STATE OF TENNESSEE
DEPARTMENT OF TRANSPORTATION
BUREAU OF ENGINEERING

I-65 INTERCHANGE AT BUCKNER ROAD
IN SPRING HILL (DESIGN-BUILD)

REV. 09/14/20: REVISED INDEX OF SHEETS.

TYPE	YEAR	PROJECT NO.	SHEET NO.
FUNCT.	2020		19A

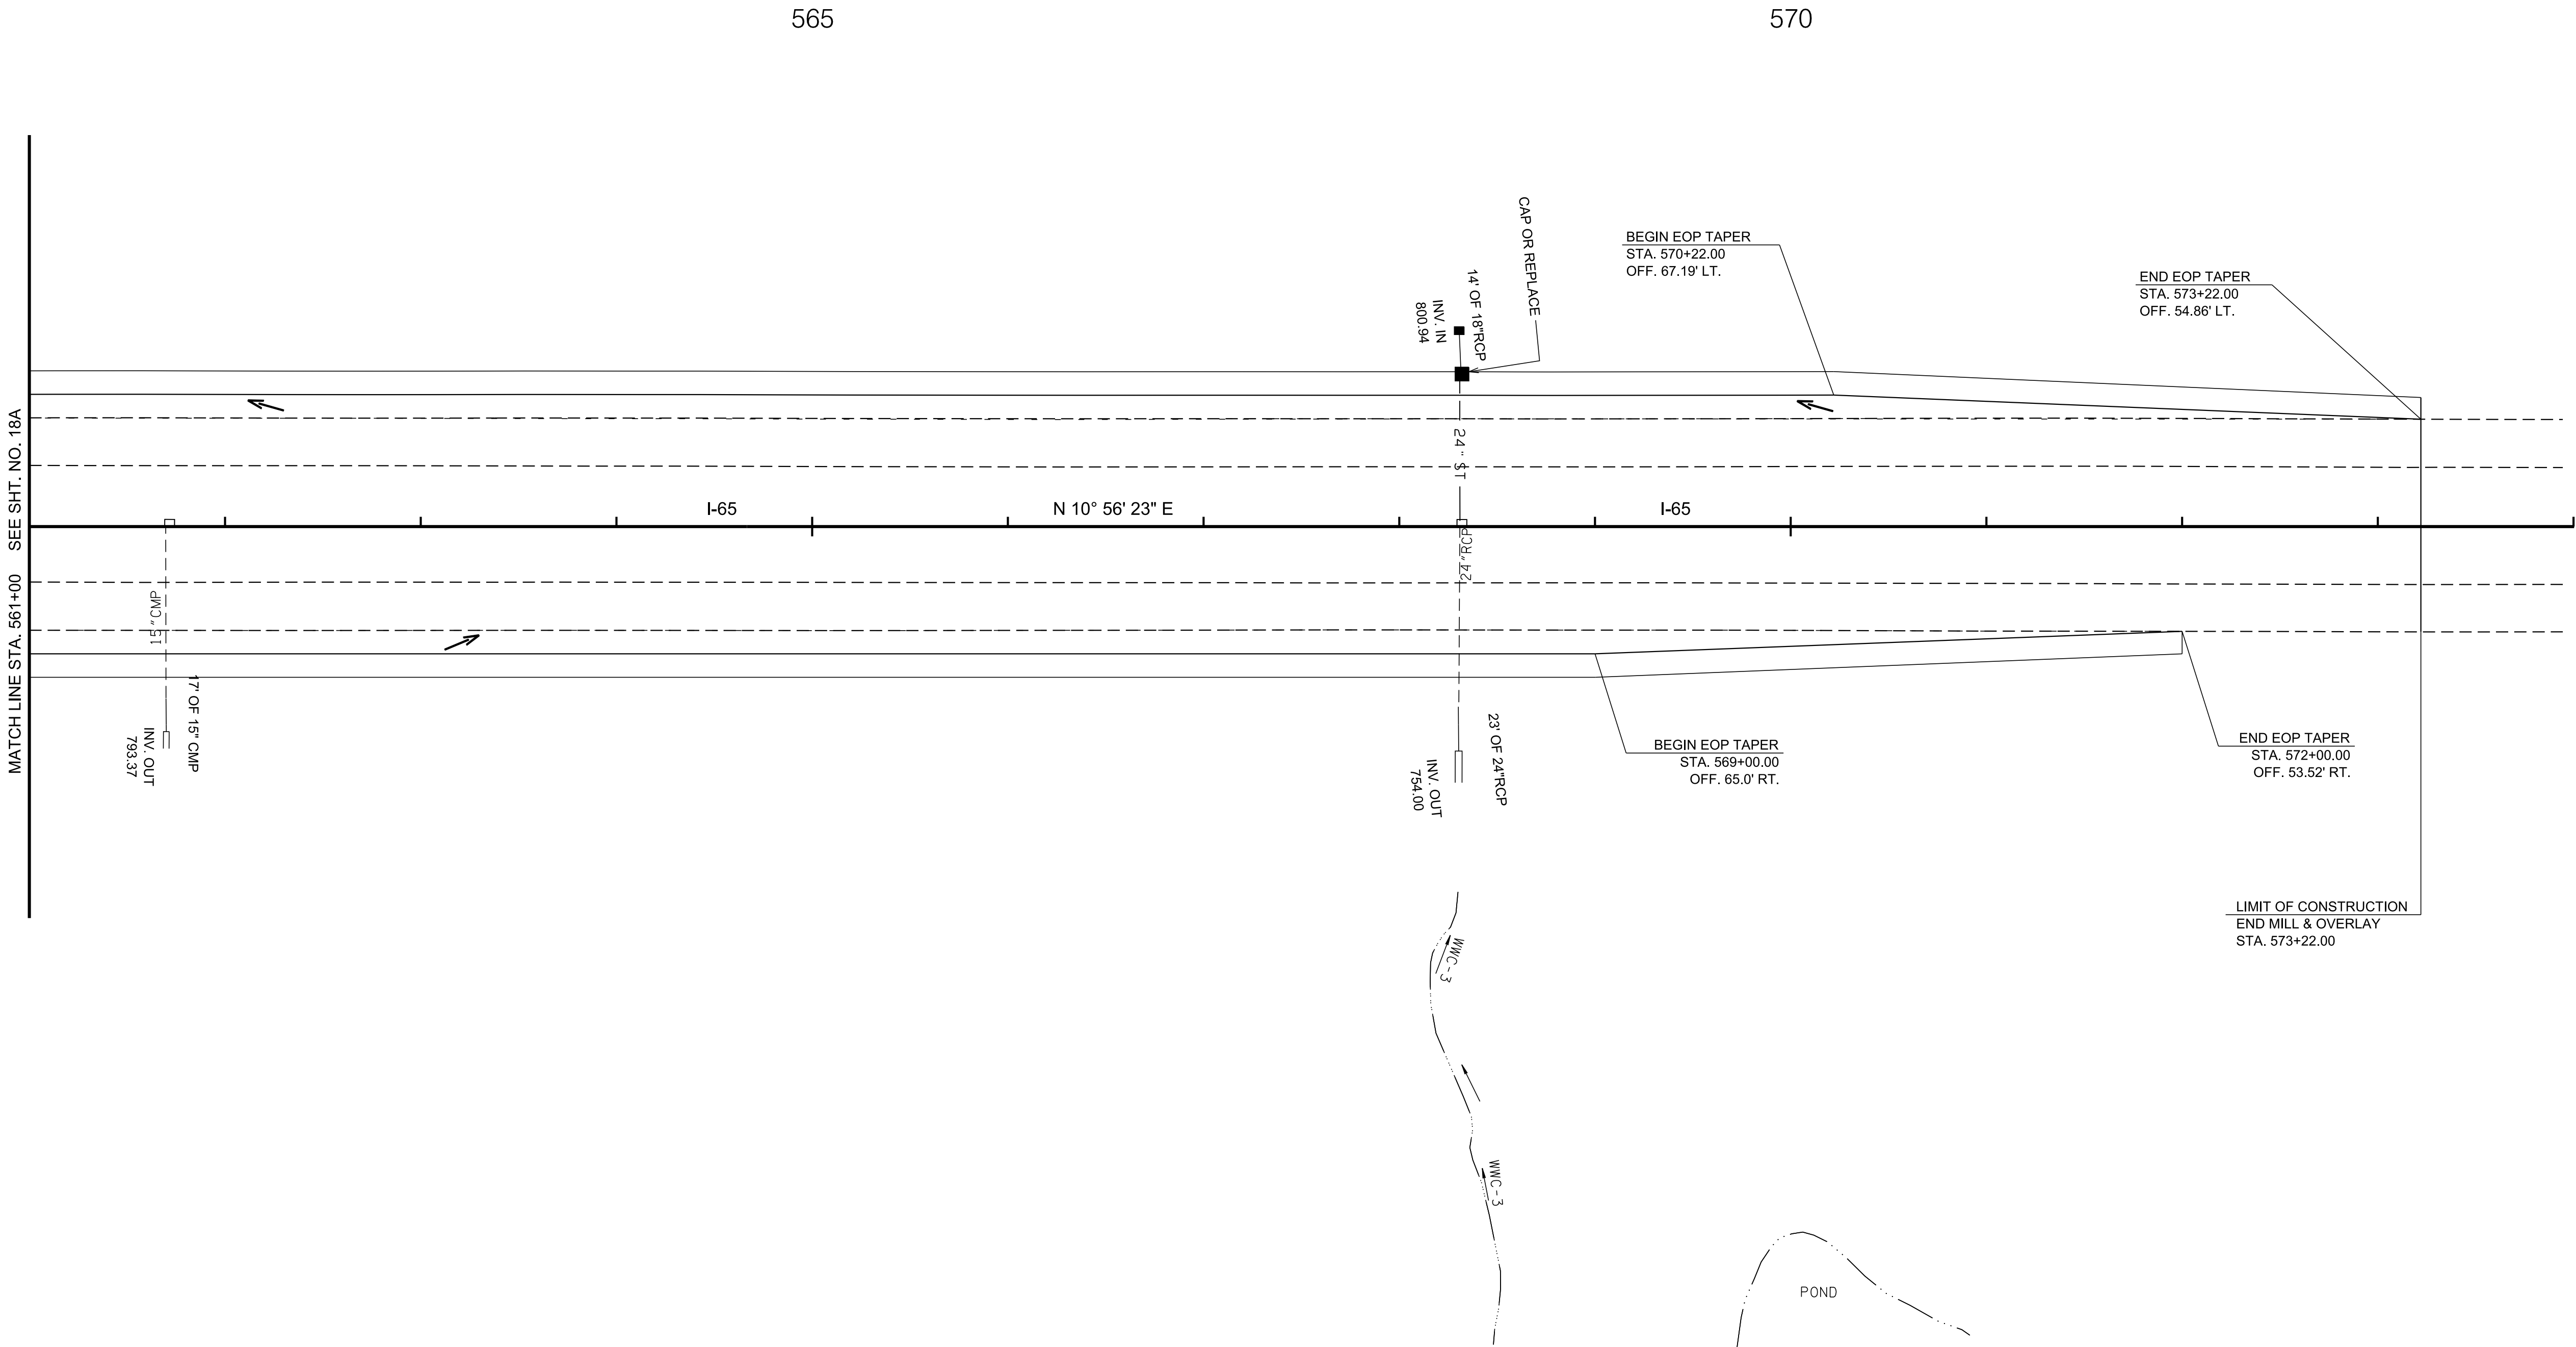
REV. 09/14/20: REVISED LIMIT OF CONSTRUCTION.
ADDED 18" RCP AND 24" RCP AT STA. 561+70.28.
REVISED SHEET NUMBER.

TYPE	YEAR	PROJECT NO.	SHEET NO.
FUNCT.	2020		20

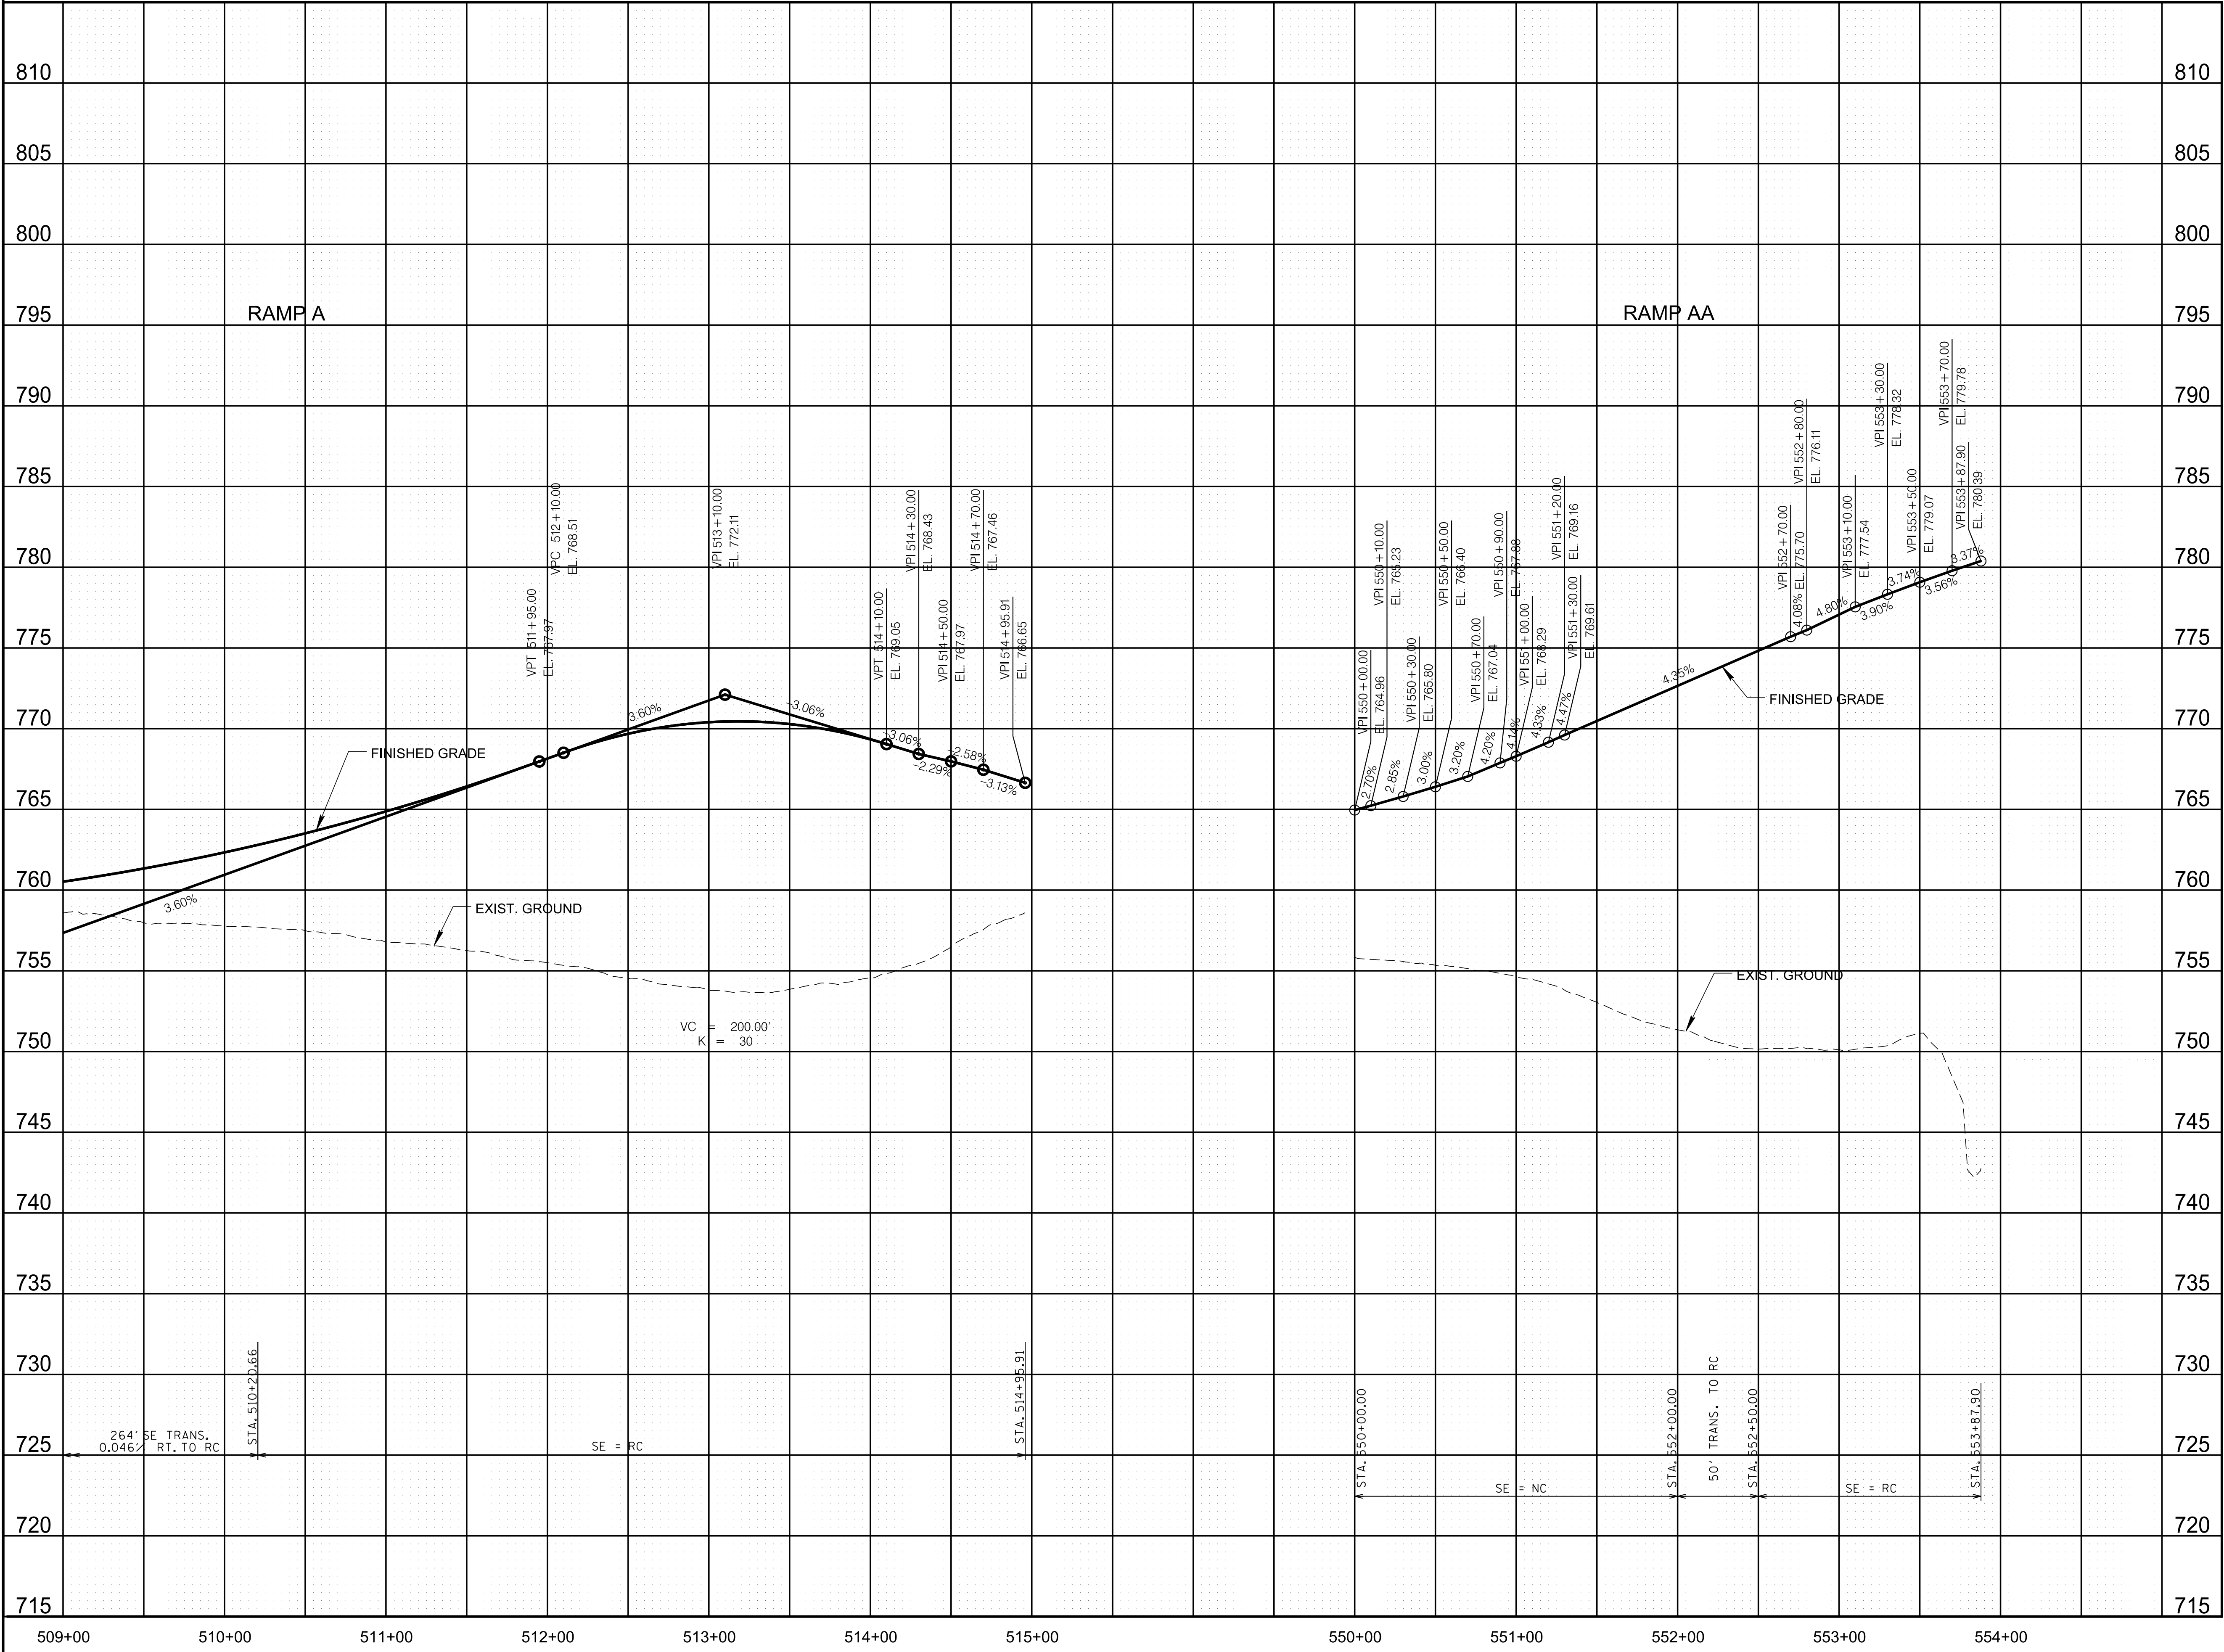
REV. 09/14/20: REVISED RAMP A PROFILE AND REVISED SHEET NUMBER.

TYPE	YEAR	PROJECT NO.	SHEET NO.
FUNCT.	2020		26

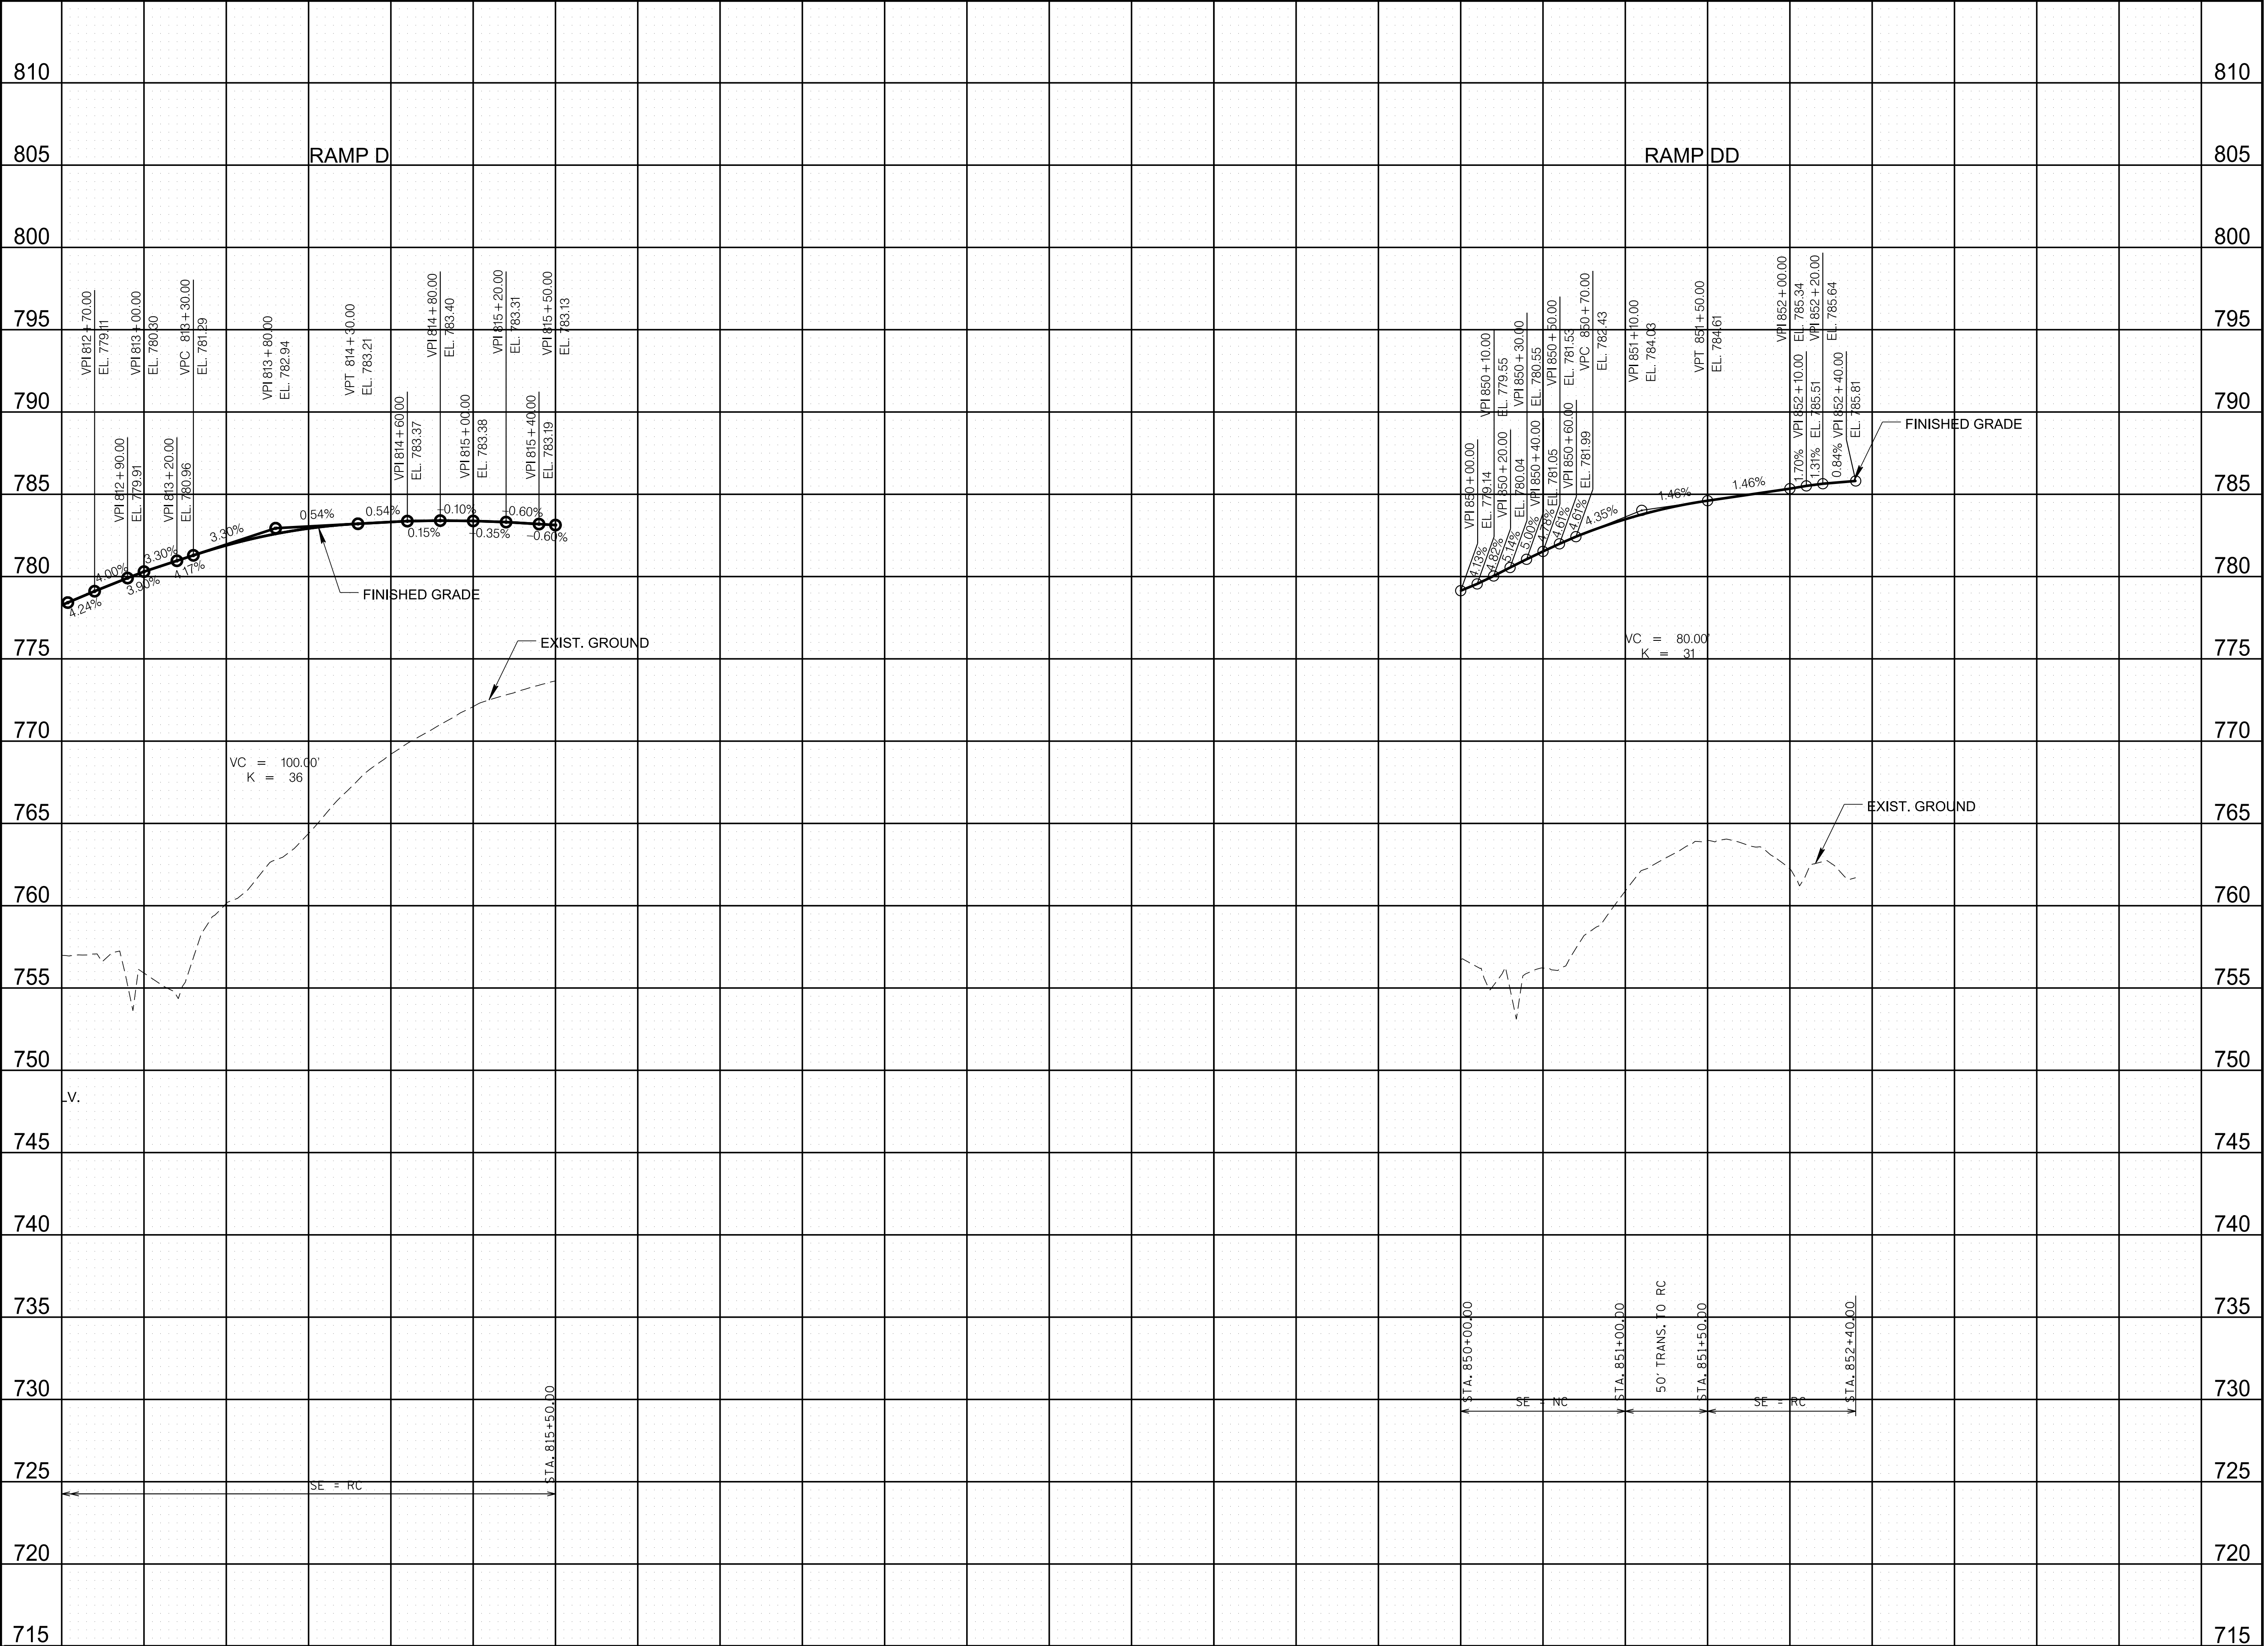
REV. 09/14/20: REVISED RAMP D PROFILE AND REVISED SHEET NUMBER.
